CITY OF LONG BEACH

OFFICE OF THE CITY MANAGER

May 16, 2017

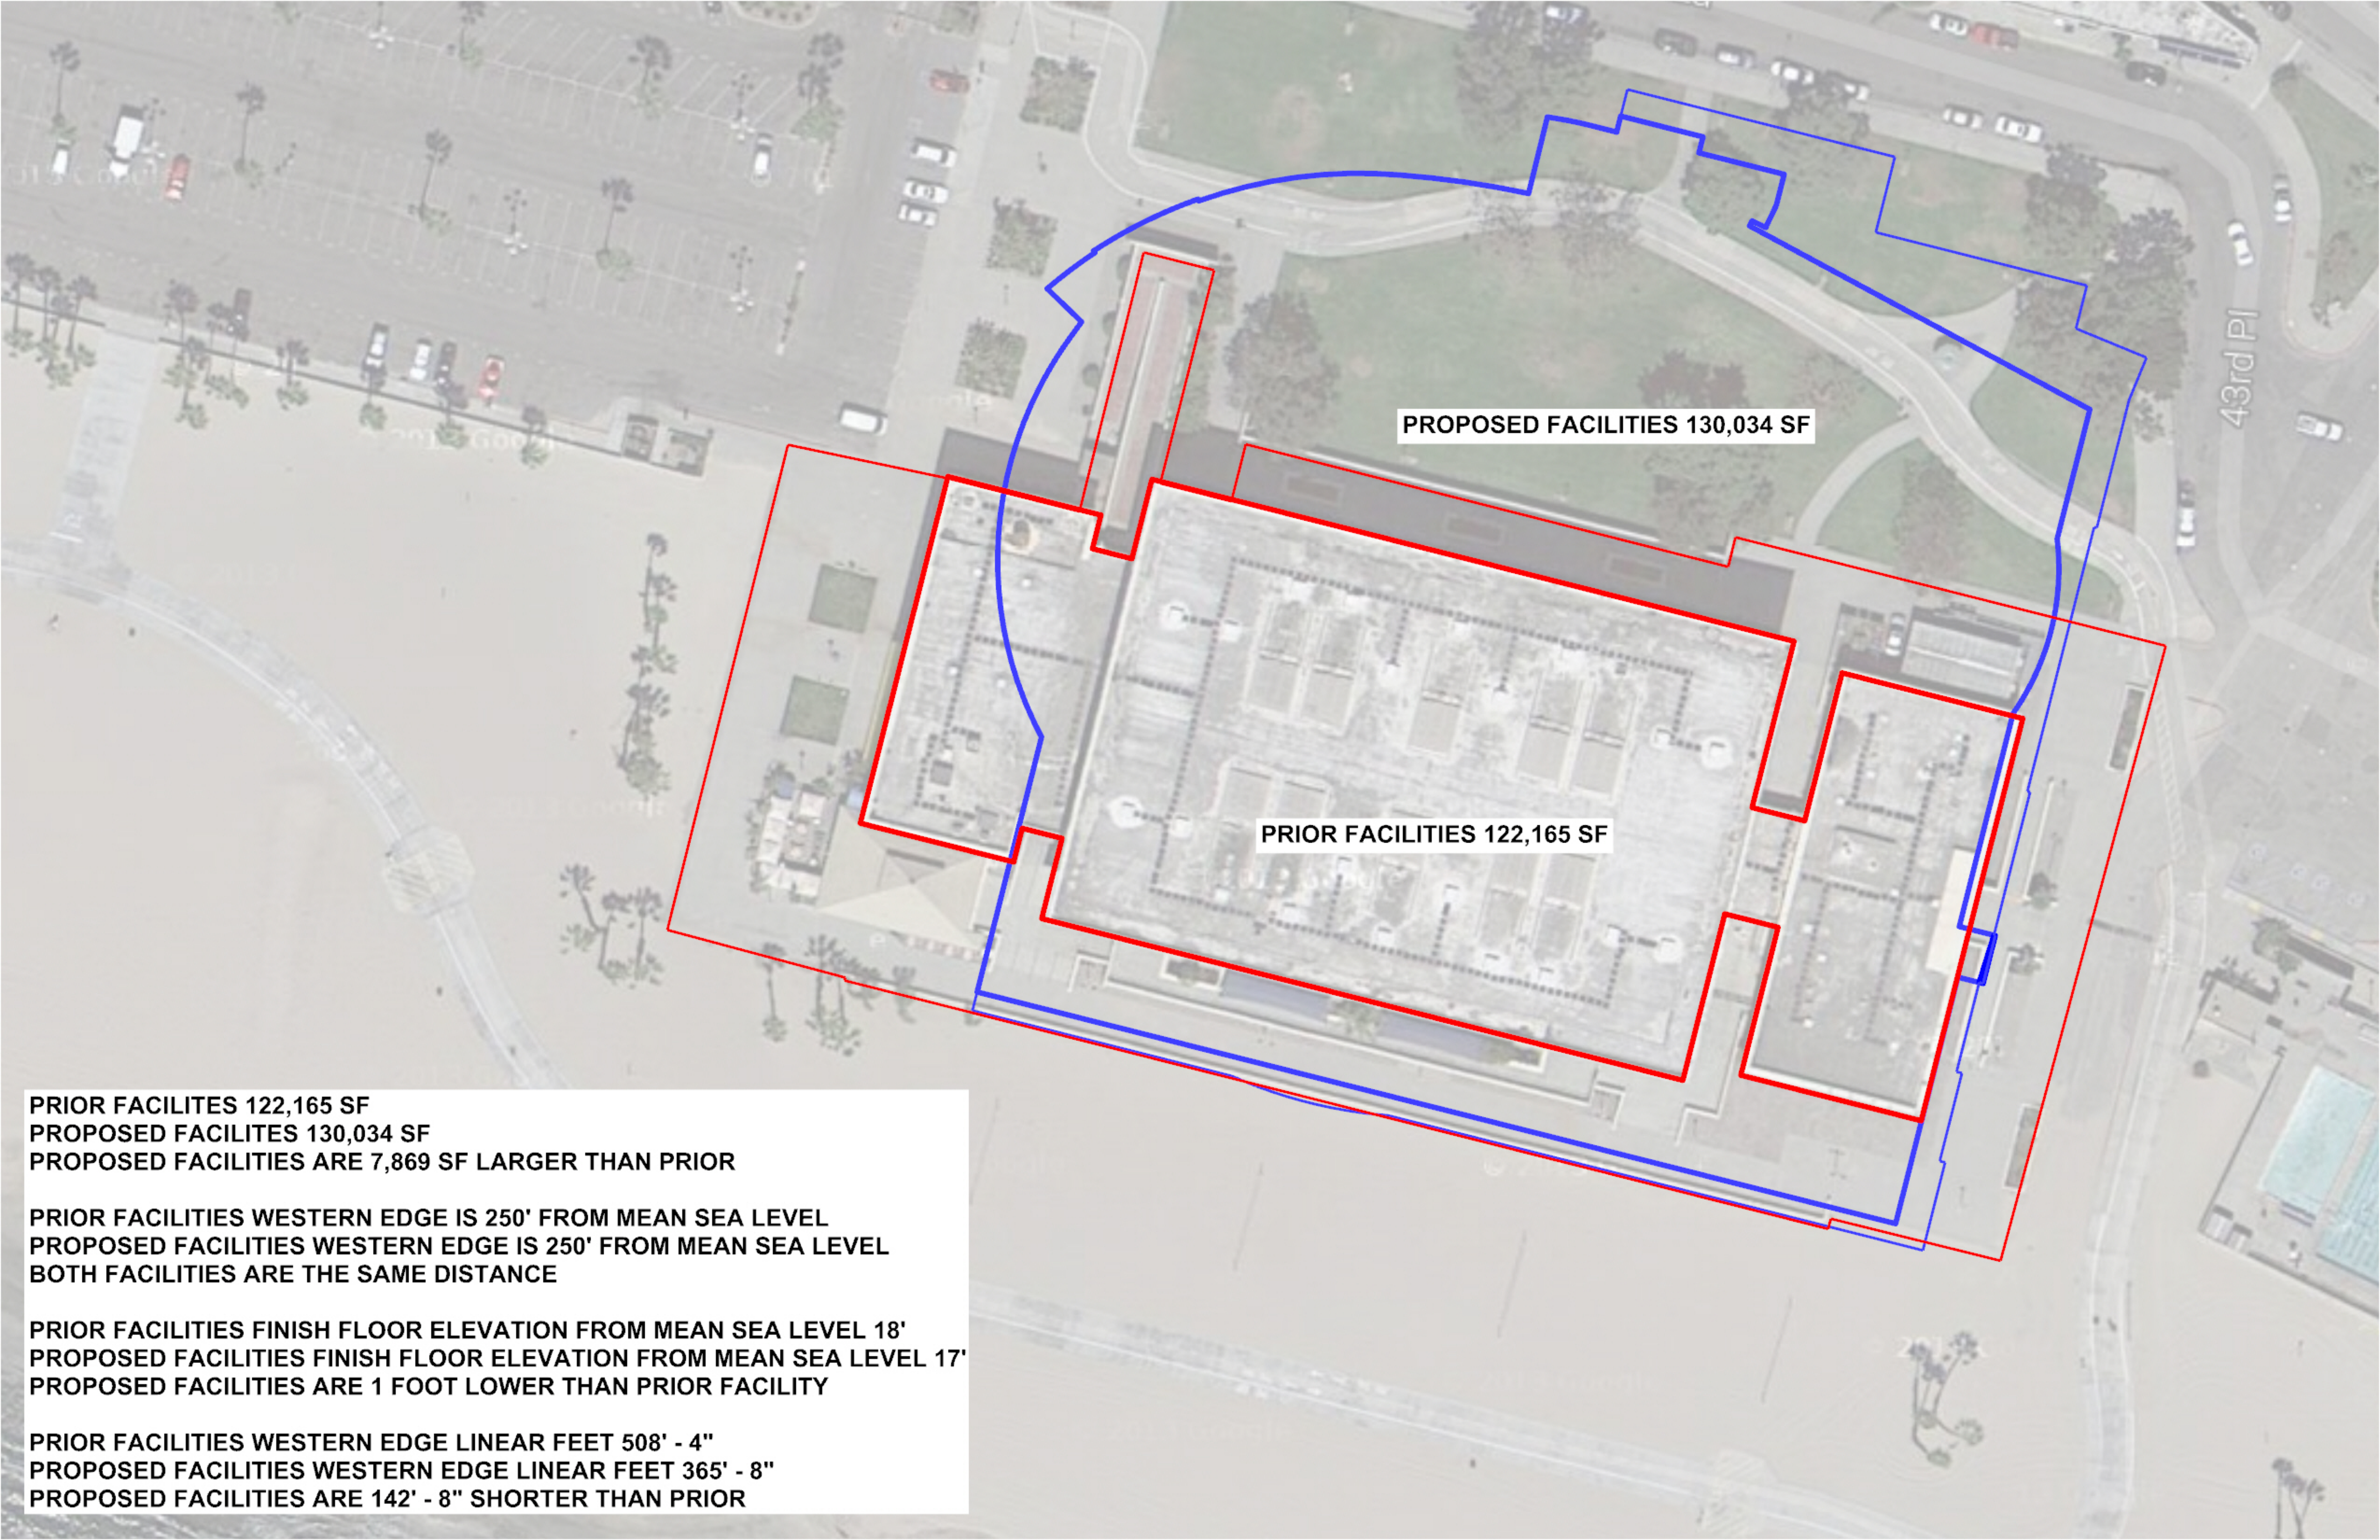
Comment Page 1, Paragraph 4: *The project appears to be designed to likely ensure the structure's stability (from an engineering perspective) if the area of the beach where the seaward portion of the structure is located becomes inundated due to sea level rise; this would be achieved by utilizing a substantial foundation that would extend not only below the expected scour level of the beach but would also be built up relatively high in elevation. As a result, this deepened foundation itself could effectively act as a seawall, or result in similar impacts to coastal resources as a seawall, raising potential issues with the hazard and shoreline development policies of the Coastal Act..., which provide that new development should be designed and located in a manner to ensure geologic and engineering stability independent of the need for shoreline protection.*

Comment Page 2, Paragraph 2: Moreover, both the Coastal Act and the City’s LCP set forth policies to protect shoreline areas for public access and recreation. Beaches are particularly vulnerable to the impacts of new development because beaches backed by fixed or permanent development, such as the new pool facility, will not be able to migrate inland as sea level rises, and will become permanently inundated over time, which will in turn present serious concerns for future public access, recreation and habitat protection.

5. The Coastal Act states that “new development” does not include: “Improvements to any structure which do not change the intensity of its use, which do not increase either the floor area, height, or bulk of the structure by more than 10 percent, which do not block or impede public access, and which do not result in a seaward encroachment by the structure.” The new pool facility meets this criteria. Additionally, the design of the public pool structure remains in conformance with the Coastal Act and the Coastal Commission’s Sea Level Rise Policy Guidance (2015) which prohibits any future construction of shoreline protection devices when in the future the building is threatened by erosion. Instead, the pool facility relies on its own deep foundation to preclude the need for a seawall to protect against erosion. Furthermore, the structure will not act as a seawall, since it is only subject to the influence of wave uprush under the conditions of a 100-year coastal storm event under the high project sea level rise scenario in the year 2100. There are many examples of structures with significant setback from the shoreline, which may be impacted during a 100-year storm event. Once the storm passes, beaches respond and lateral access is restored.

6. As stated above, the project represents the replacement of an important public access resource in the City of Long Beach – not new development. From the inception of the project, the City’s intention was to create a replacement facility for the Belmont Pool, which was demolished for safety reasons. The City’s coastal development permit for the demolition also contemplated rebuilding the facility in this location. The City took into account the placement on the site as the design was developed. The new pool structure’s seaward footprint is located in the same location as the original pool structure. The new structure is 143 feet narrower in its east to west (beach frontage) dimension. The new structure’s plinth is 1 foot lower than the original pool structure’s plinth, and is oriented as landward as possible within a very stable portion of the City shoreline in terms of erosion and flood risk. As stated in Response #4, the City would like to discuss with the Coastal Commission ways to continue to proactively implement current adaptation strategies such as sand management and beach nourishment and potentially other measures to reduce erosion and flood risk, even though these measures are not needed for the pool facility. Given the fact that the pool location is in much more protected area than the shoreline to the east, these adaptation strategies would most likely be implemented well before the need would arise at the pool location.

PROPOSED FACILITIES 130,034 SF

PRIOR FACILITIES 122,165 SF

**PRIOR FACILITIES 122,165 SF
PROPOSED FACILITIES 130,034 SF
PROPOSED FACILITIES ARE 7,869 SF LARGER THAN PRIOR**

**PRIOR FACILITIES WESTERN EDGE IS 250' FROM MEAN SEA LEVEL
PROPOSED FACILITIES WESTERN EDGE IS 250' FROM MEAN SEA LEVEL
BOTH FACILITIES ARE THE SAME DISTANCE**

**PRIOR FACILITIES FINISH FLOOR ELEVATION FROM MEAN SEA LEVEL 18'
PROPOSED FACILITIES FINISH FLOOR ELEVATION FROM MEAN SEA LEVEL 17'
PROPOSED FACILITIES ARE 1 FOOT LOWER THAN PRIOR FACILITY**

**PRIOR FACILITIES WESTERN EDGE LINEAR FEET 508' - 4"
PROPOSED FACILITIES WESTERN EDGE LINEAR FEET 365' - 8"
PROPOSED FACILITIES ARE 142' - 8" SHORTER THAN PRIOR**
